Chabot-Las Positas Community College District

CHANGE ORDER

OWNER	Chabot Las Positas Community College District	Contract # 552315
ARCHITECT	Harley Ellis Devereaux	Architects Project #:2015-30004-000
CONTRACTOR	W. A. Thomas Co. Inc.	DSA File # 1 - C2
		DSA App. # 01-116361

PROJECT:	Biological Sciences Building Annex B2100 Phase 1	CHANGE ORDER NUMBER: 013 INITIATION DATE: September 30, 2021
-----------------	---	---

17. BULLETIN CABINET AT MANIFOLD - PLAN

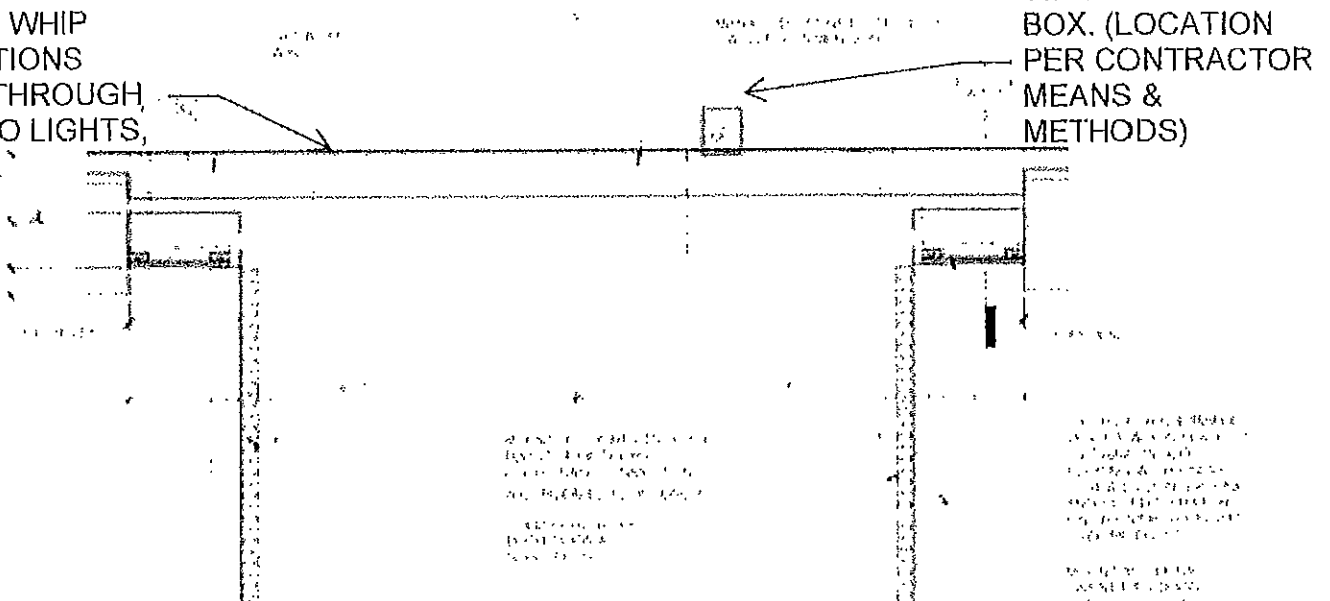
1. What is the intent of the connection for the power to bulletin boards? Per the contract drawings these boards are powered by a single junction box in the ceiling controlled by the corridor lighting circuit.
2. There will now be (4) locations that require a double door installation which will require 4 additional junction boxes. We propose to mount these boxes behind the bulletin board in the open wall for access for service later. Please advise as this will incur extra material & time.
3. The remaining (2) location will also require extra work. The provided cord doesn't reach any accessible ceiling space. We propose installing a junction in the classroom on the screen wall for access to splices. This will receive a blank plate but will be seen from classroom. Please advise as this will incur extra time, cost and visual impact

Arup Response:

BULLETIN CABINET AT MANIFOLD - PLAN

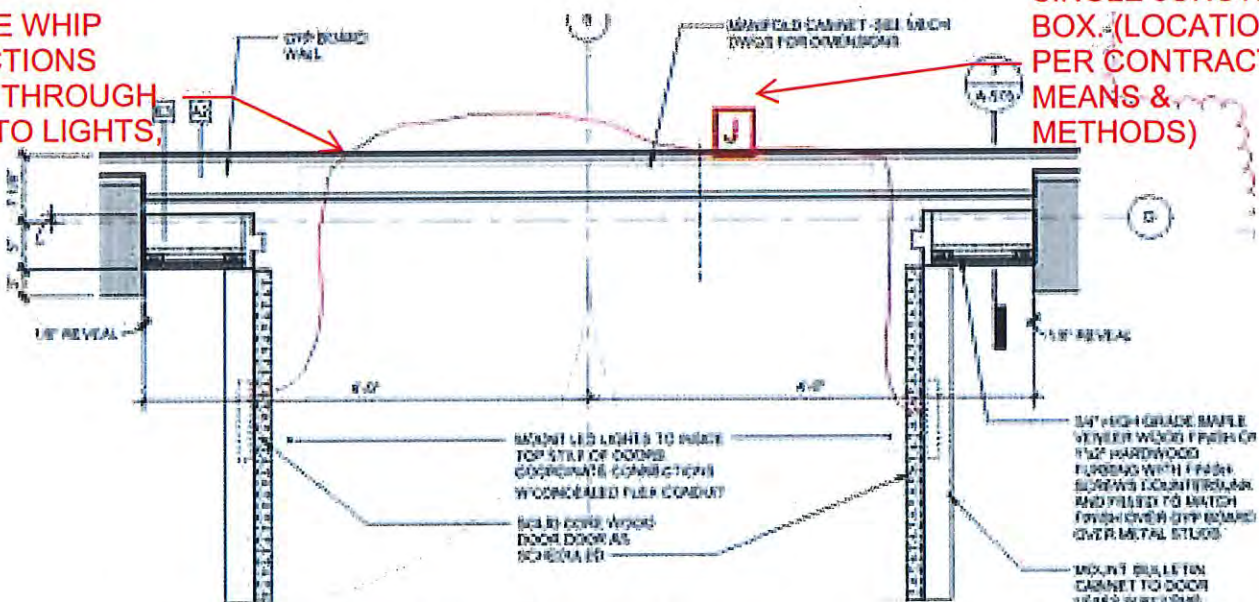
1. What is the intent of the connection for the power to bulletin boards? Per the contract drawings these boards are powered by a single junction box in the ceiling controlled by the corridor lighting circuit.
2. There will now be (4) locations that require a double door installation which will require 4 additional junction boxes. We propose to mount these boxes behind the bulletin board in the open wall for access for service later. Please advise as this will incur extra material & time.
3. The remaining (2) location will also require extra work. The provided cord doesn't reach any accessible ceiling space. We propose installing a junction in the classroom on the screen wall for access to splices. This will receive a blank plate but will be seen from classroom. Please advise as this will incur extra time, cost and visual impact

Arup Response:

Except from Bulletin #06

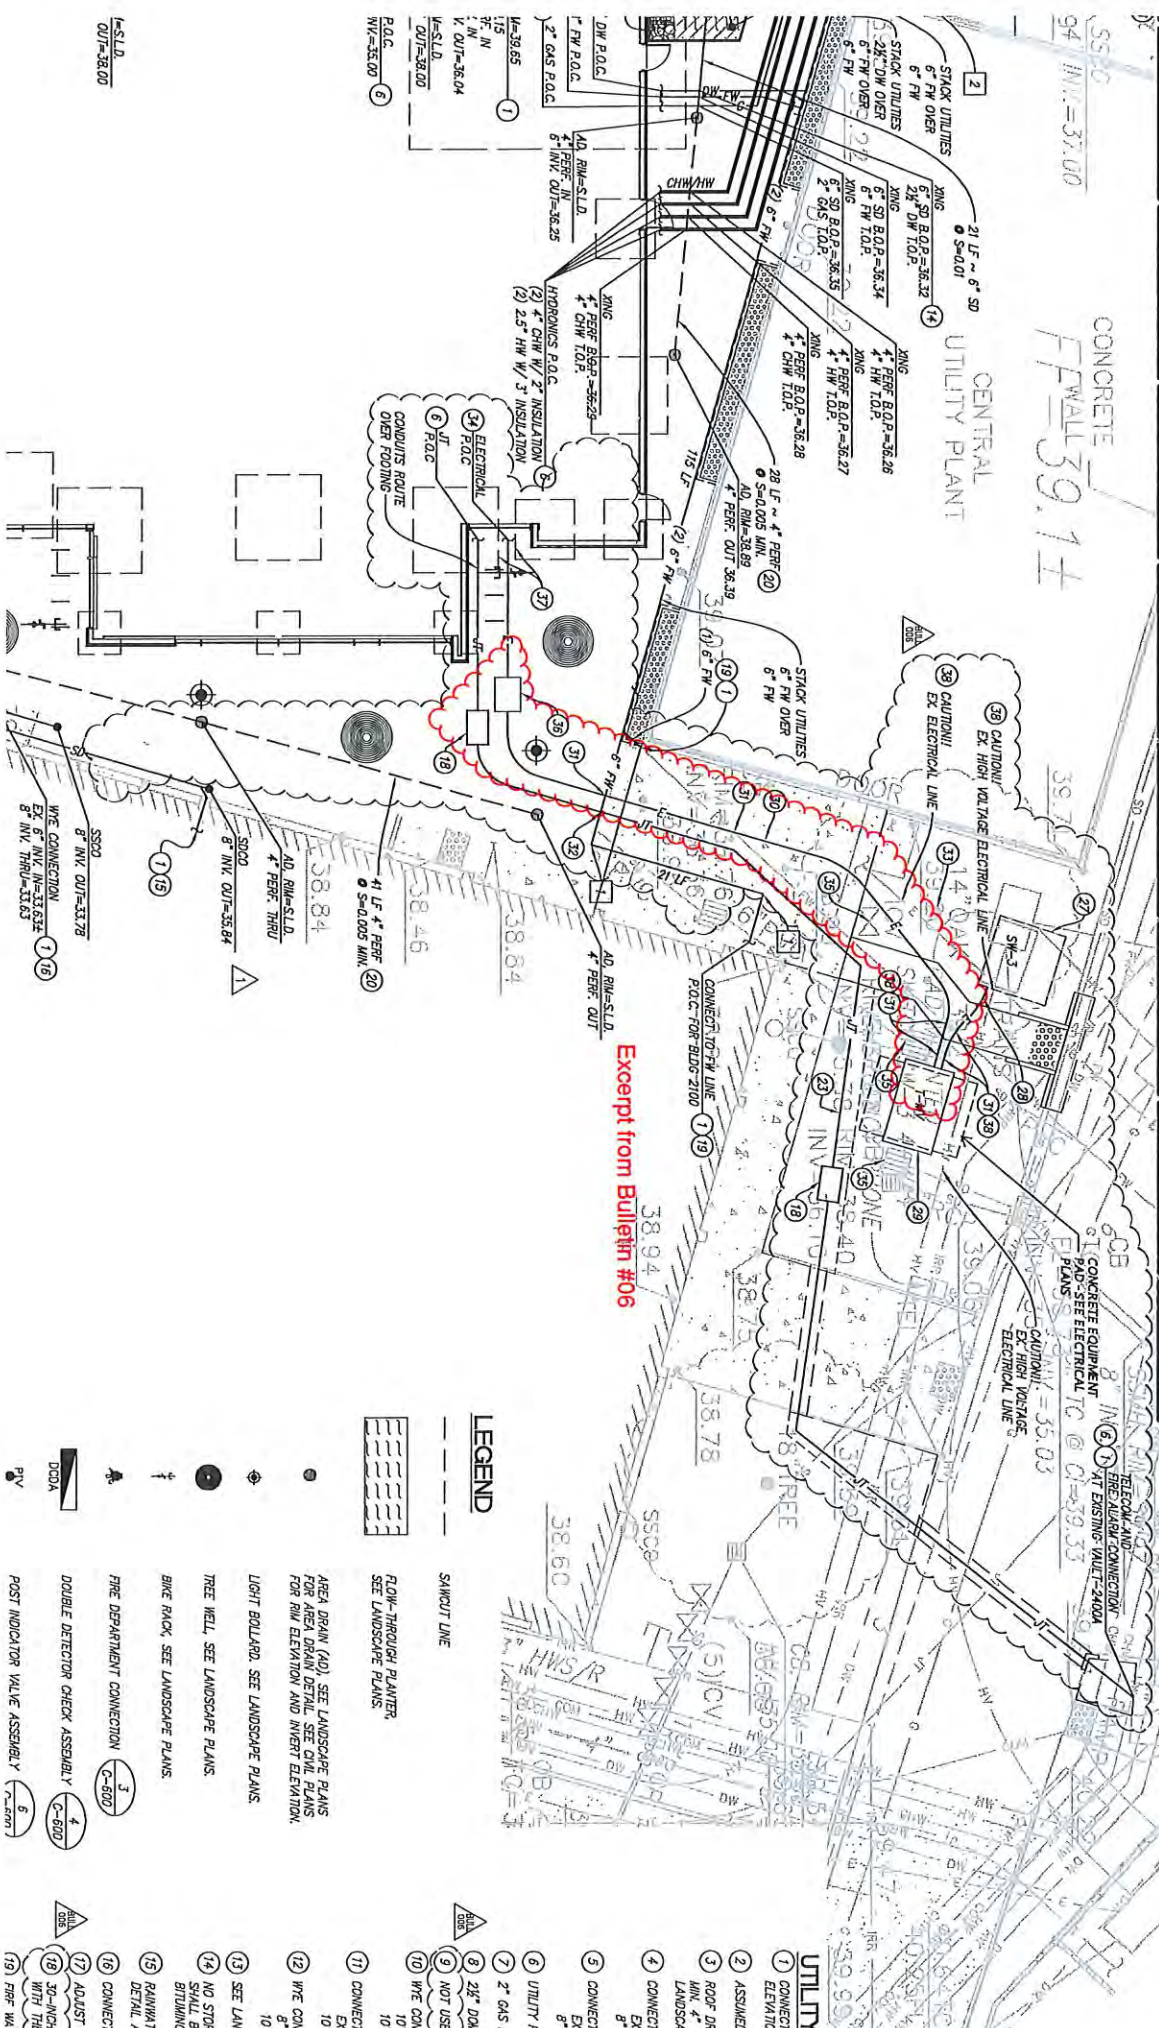
<u>Item</u>	<u>Hrs</u>	<u>Material / Equip.</u>	<u>Labor</u>	<u>Subcontractor</u>	<u>Total</u>
<u>Change Description:</u>					
Offhaul excess spoils associated with Bulletin #06					
Electrical Trench work					
<u>Breakdown of Estimated Subcontractor Costs:</u>					
				\$0	\$0
MJR Work Summary dated 12/17/20				\$1,070	\$1,070
Khaira Trucking Cost summary 12/24/19 Prorated				\$693	\$693
<u>Qualifications: Price for itemized work only listed on subcontractor quotation. Overtime excluded. Any extra work not noted or unforeseen conditions will be priced separately.</u>				\$0	\$0
				\$0	\$0
<u>W. A. Thomas Co., Inc. Work</u>					
					\$0
Costs are those only associated with Michael J. Rodola	0	\$0	\$0		\$0
	0	\$0	\$0		\$0
	0	\$0	\$0		\$0
	0	\$0	\$0		\$0
		\$0	\$0		\$0
<u>Subtotal</u>		\$0	\$0	\$1,763	\$1,763
Tax 10%					\$0
15% on WATCO work					\$0
5% on Subcontractor Costs (\$618+ \$955 = \$1573)					\$78

TITLE: FIRST & SECOND FLOOR PIPING PLANS
 SHEET NO.: M-201

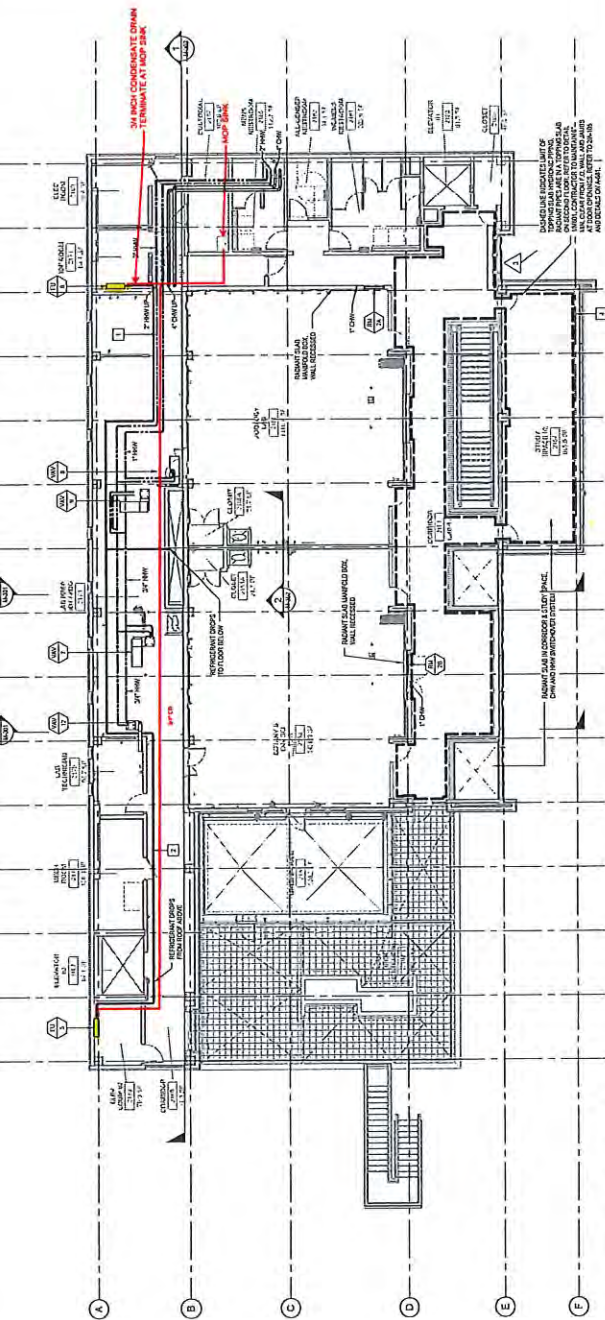
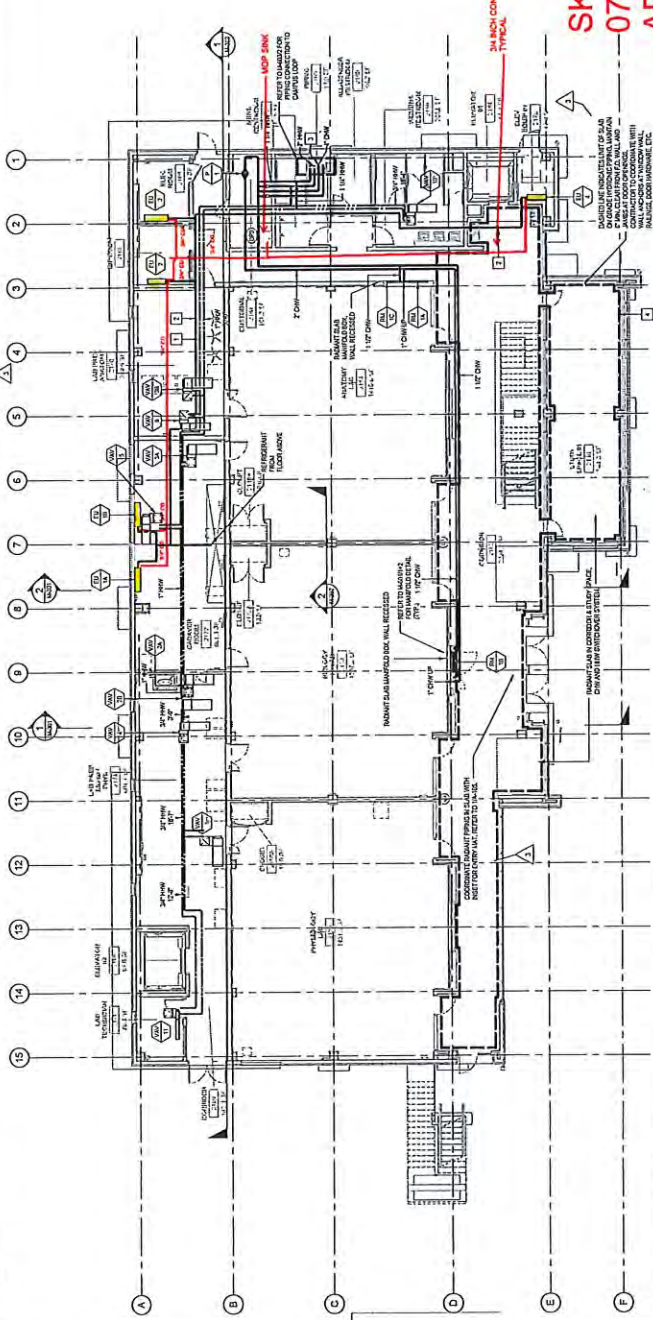
Please see attached FWS RFI 146, Dated 7/15/2020 : On the contract drawings there is not any drain piping shown for any of the EU units. No condensate pipe is included in the model. Mechanical schedule M-002 indicates there is to be plumbing piping for condensate removal for 2 units EU-1A and EU-1B.

Condensate Drain at each unit is required per drawing M002.

1. Provide 3/4 inch condensate drain, copper type L per specification 23 21 13 section 3.8 B.
2. See attached sketch showing pipe routing
3. Terminate at Mop Sink

Harris RFI 146.1
07-24-2020

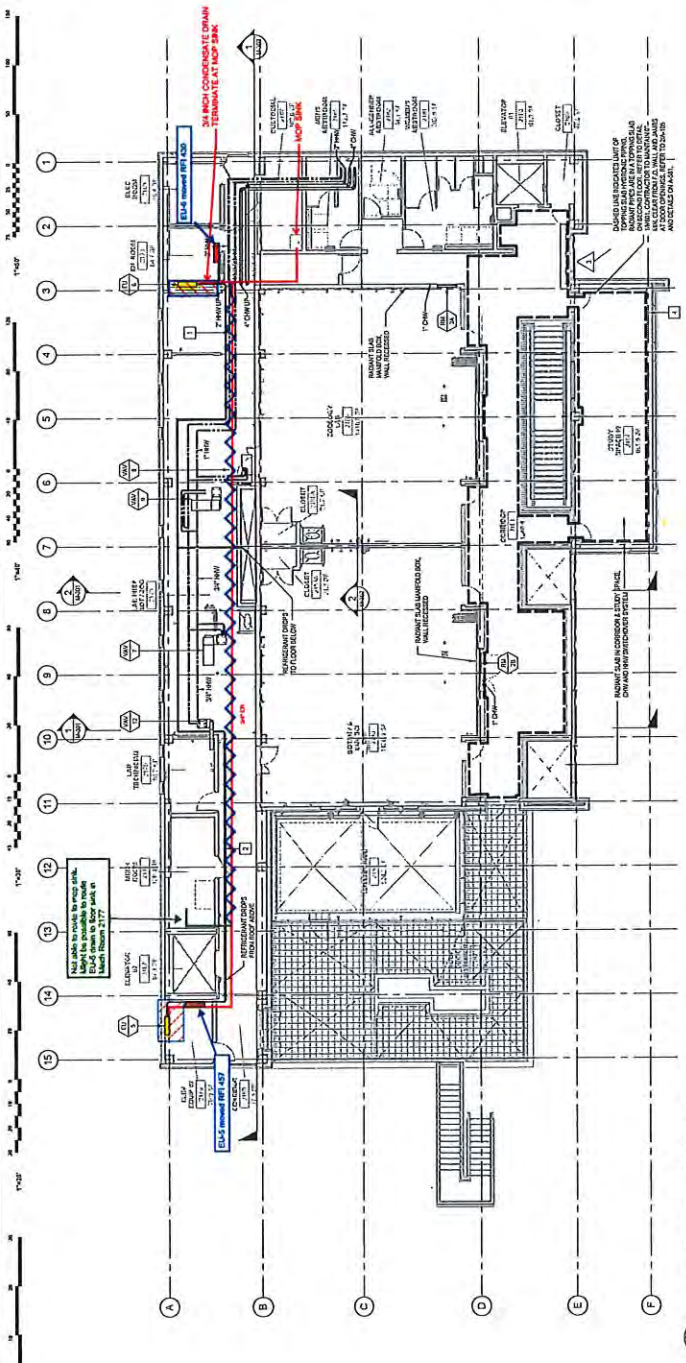
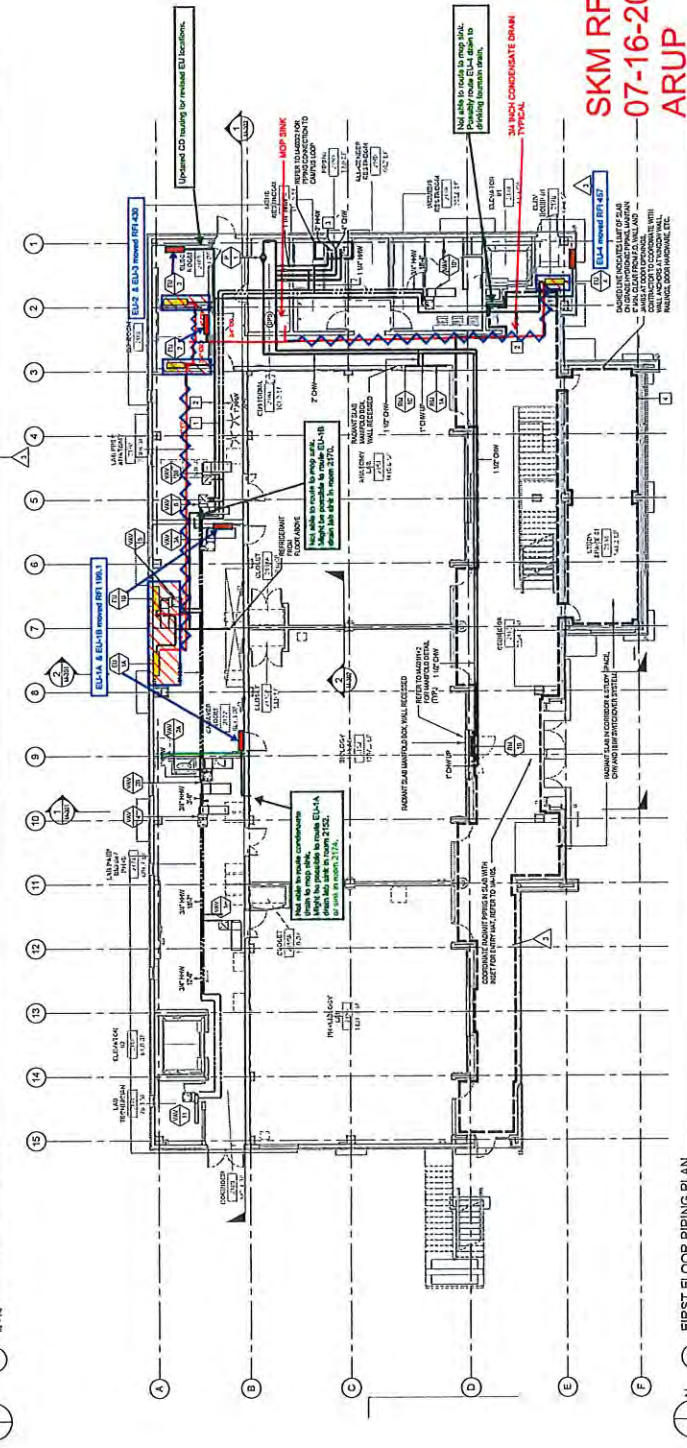
The response to RFI 504 (Harris #146) directed Harris to terminate all EU condensate lines to a single mop sink on each floor. Due to structural beams, and similar obstacles, the mop sink termination location will not work for all the EU units. The routing in RFI 504 will require the condensate pipe to drop below the ceiling.

Please note the EU units are not shown in the correct locations on the RFI response, they were moved per the following RFIs:

EU-1A & EU-1B per RFI 199.1 (location approved in shop drawing submittal #230500-221-001)
EU-2, EU-3 & EU-6 moved per RFI 430 / RFI 430.1
EU-4 & EU-5 moved per RFI 457 / RFI 457.1

Please see attached mark up of RFI 504 response showing the correct EU locations (orange) and possible condensate drain route and termination locations (green).

RESPONSE: No exceptions taken to contractor proposals. All condensate piping is to be provided with a condensate drain pan.

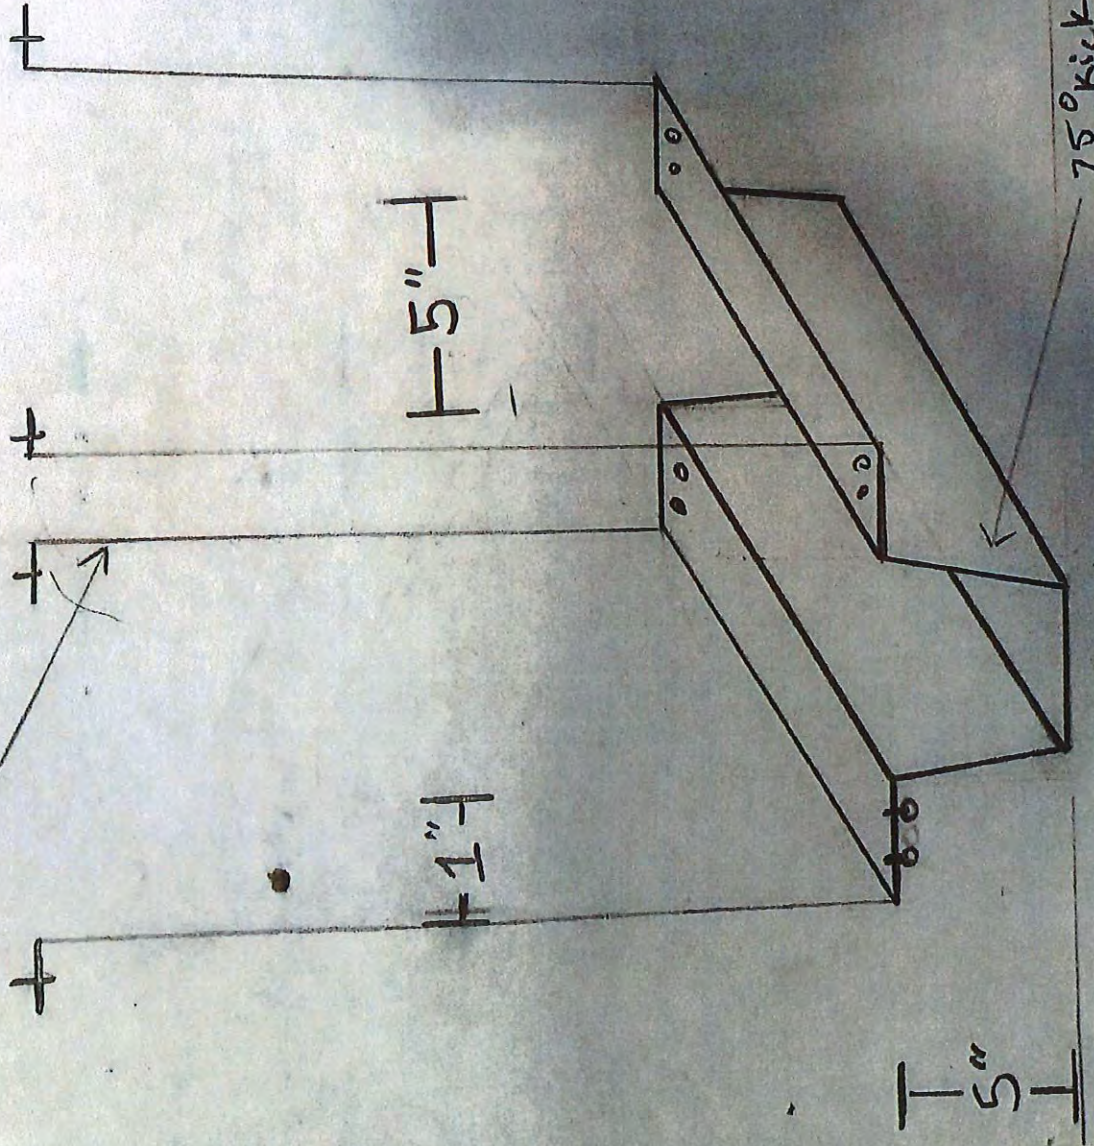
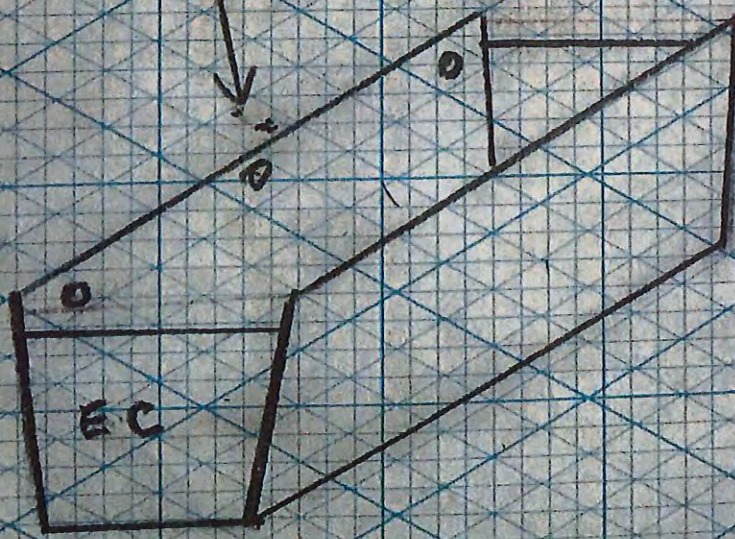
Info.Req: Please see attached FWS RFI 146.2 : The response to RFI 504.1 (Harris #146.1) directed Harris to provide condensate drain pan for ALL condensate piping.

The response did not specify how the drain pan should be installed. Will a V hanger with sheet metal angle be acceptable?

12' long sections of sheet metal.

Overlap each connection.

Secure connection and end caps with sheet metal screws with rubber washers.

Seal each connection with Sikaflex.

Mounted to wall with Hilti 3/4" X-U fastener (shot pin).
